ARKANSAS NUCLEAR ONE - UNIT 2

CEN-157(A)-NP

RESPONSE TO QUESTIONS  
ON DOCUMENTS SUPPORTING  
THE ANO-2 CYCLE 2  
LICENSE SUBMITTAL

APRIL 1981

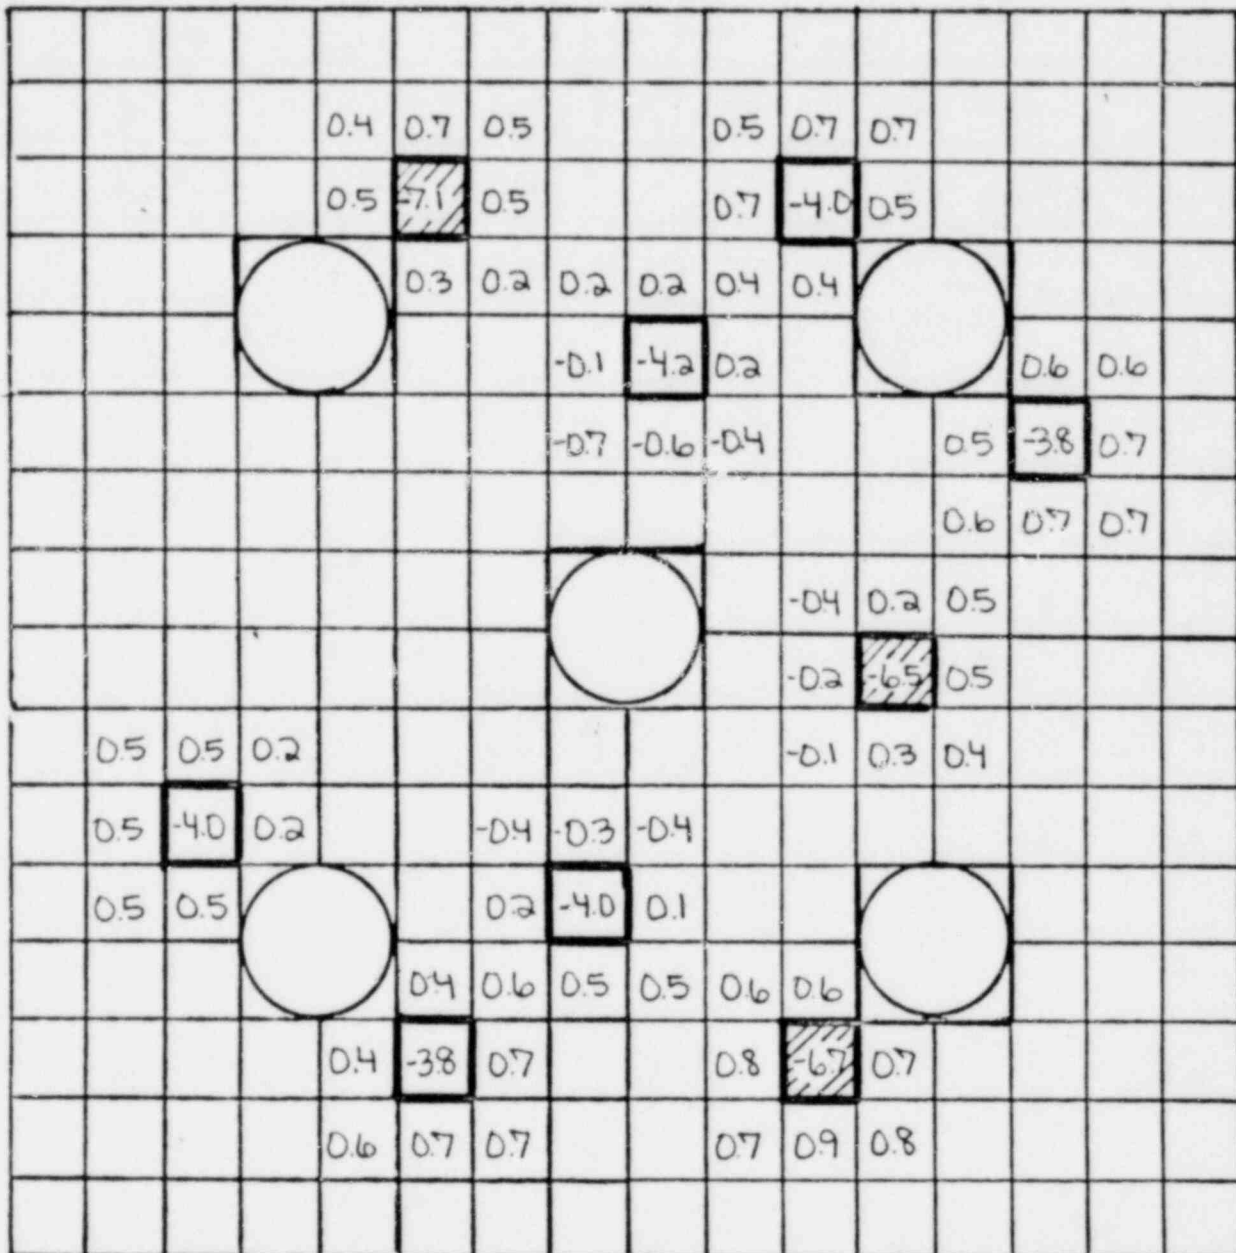
Question C-4

(Paragraph 10.3) It is not intuitively obvious that the annular pellets will have lower local peaking factors or that they will not impact neighboring rods. Provide explicit physics calculations to prove the assertions of this paragraph.

Figure 1 provides a comparison of PDQ calculations with and without annular pellet fuel rods in the configuration of the DOE high burnup demonstration assembly. It can be seen from this figure that fuel rods containing annular pellets are at least 3.8% lower in peaking than standard rods in the same locations. As Figure 1 also shows, the impact on neighboring rods is negligible, particularly in the context that these demonstration bundles are at low power levels in Cycle 2.
